REQUEST FOR INFORMATION	DATE: March 10, 2016	NO.: RFI-011
--------------------------------	-----------------------------	---------------------

Project Name: Webster University Interdisciplinary Science Building

Subject: Installing blockout for AHU install

Overall Elevation View: Right - Shipping splits indicated by bold outline. - Measurements in inches

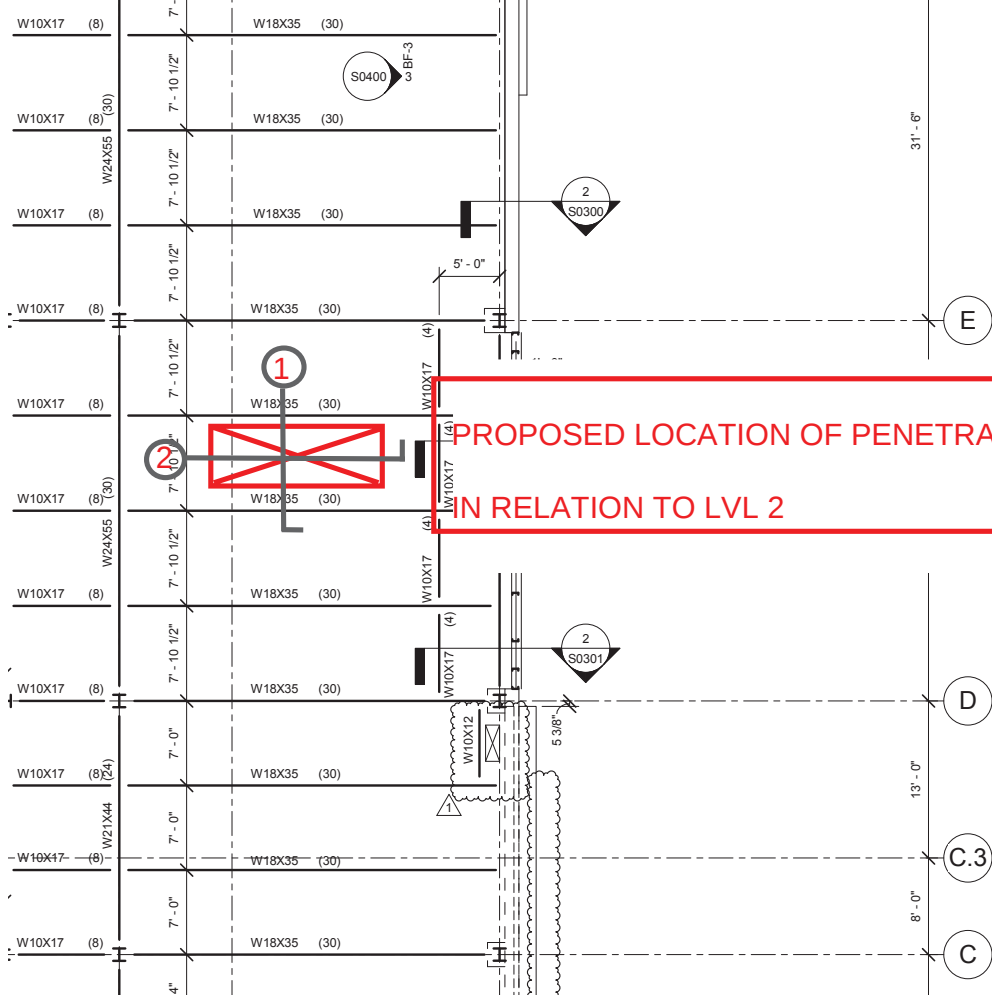
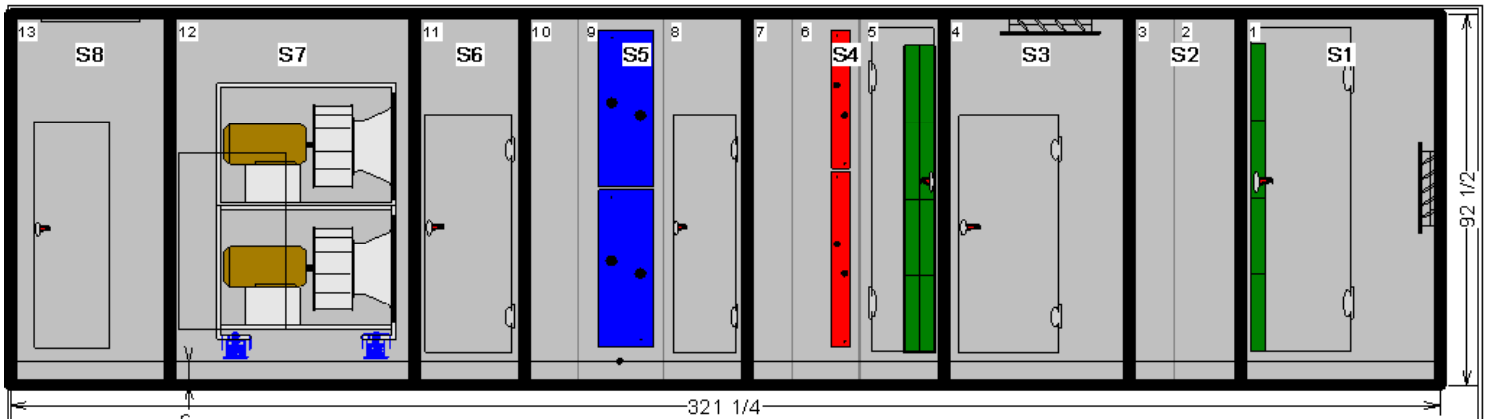
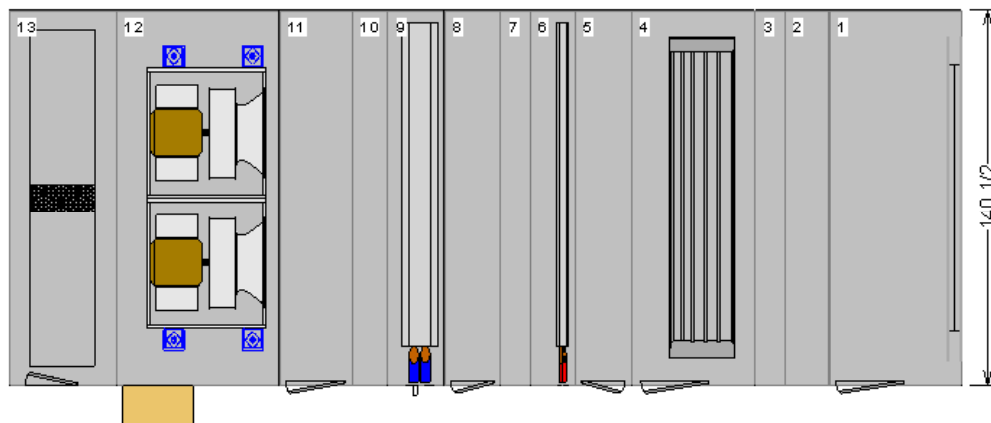
Please advise if a temporary blockout can be installed in the 1st floor slab in order to provide access to install AHU-1 and 2 once the building is enclosed. The AHU's would enter thru double door # x178.2. See attached Trane information sheet indicating unit S7 is 54 7/8" x 140 1/2" x 92 1/2" tall x 3823 lbs. The proposed blockout would be 7'4 1/2" x 16'. Once the units are lowered into the basement the temporary blockout would be decked across with metal deck and concrete placed.

The design direction thus far has been that the AHU's would be built on site in the basement with equipment being delivered to basement from the elevator. An alternative to this method has been proposed where a gantry crane will be used to drop prefabricated sections through a temporary opening in the floor. The proposed alternative approach will require redesign, loading checks, additional details, and drawing modifications. In short, this is a viable option but additional services are required for structural. Design verifications will be necessary for the delivery path and gantry crane to hoist the equipment down. There will be drawing modifications and some additional steel & reinforcing required. Additional information and coordination will be necessary with WTA and the equipment installation contractor in order to verify and modify the current system.

1. Loading checks will need to be performed, however, I anticipate with the 4k load, minimal changes to the design will be required for the access path.
2. Loading due to the gantry crane hoisting procedure will need to be performed. Based on the 4k equipment load and the current design live load on L1, it is anticipated that few revisions will be required.
4. There will be extra requirements at the perimeter of the opening. DBS reinforcing will be required along the perimeter. Additional reinforcing for slab continuity will also be required.

SECTION 1

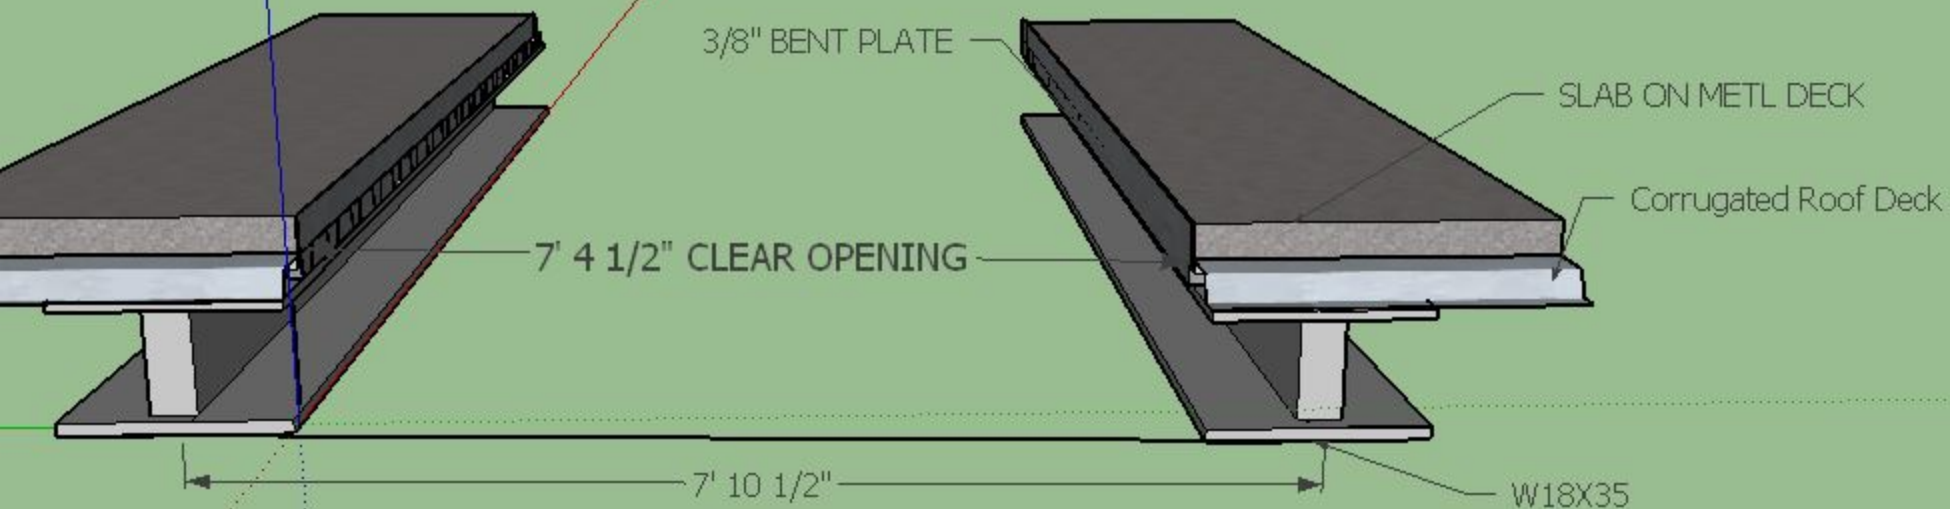
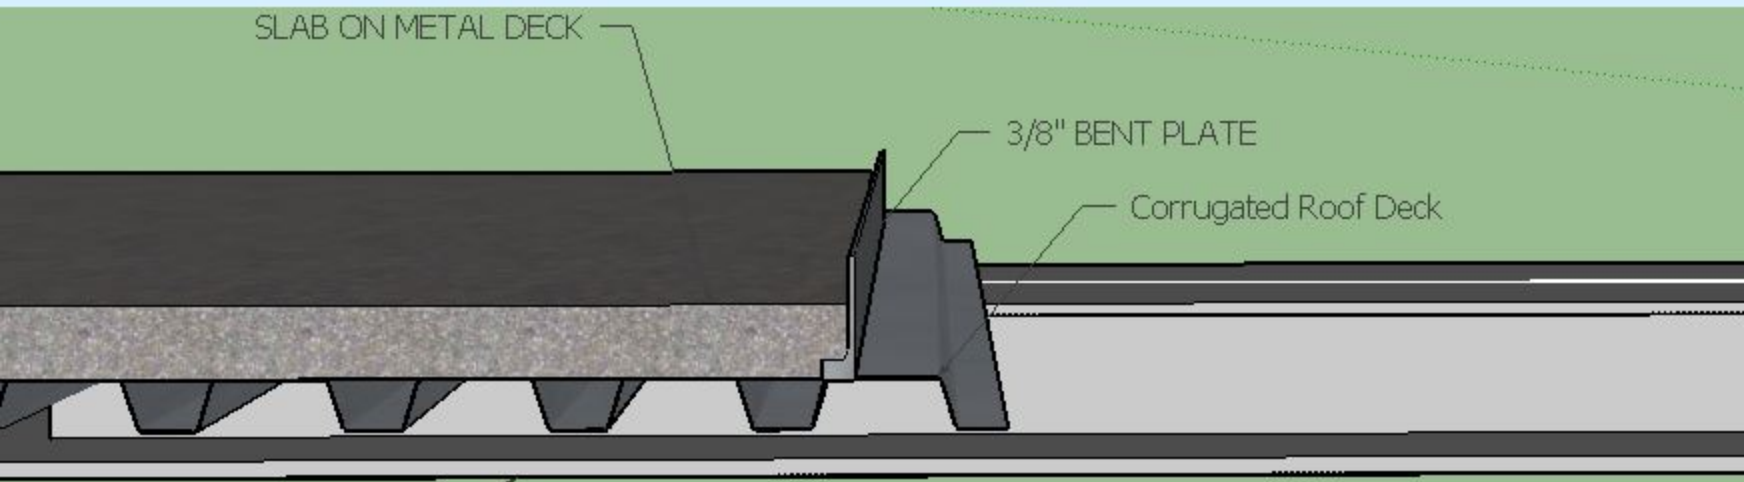
1. Please verify if the unit can be loaded thru the double door and rolled across the 1st floor slab without overloading the slab.
2. Please verify the unit can be hung from the structural steel underneath the 2nd floor slab and lowered down into Level 0.
3. Please verify if a gantry crane can be set on the 1st floor on either side of the floor blockout to lower the unit into the opening. This would apply a point load to the 1st floor. Gantry crane example:
http://www.globalindustrial.com/p/material-handling/hoists-cranes/cranes-gantry/gorbel-steel-gantry-crane-25-ft-span-and-17-ft-20-ft-adjustable-height-10000-lb-capacity?infoParam.campaignId=T9F&gclid=CjwKEAiA04S3BRCYteOr6b-roSUSJABE1-6BuuJzODfznvzBS3PcKuUzK0ALDMkpJ7gdm3BoCOTHqBoC2nzw_wcB
4. Please verify if any additional reinforcing is required at the perimeter of the blockout or infill hole.
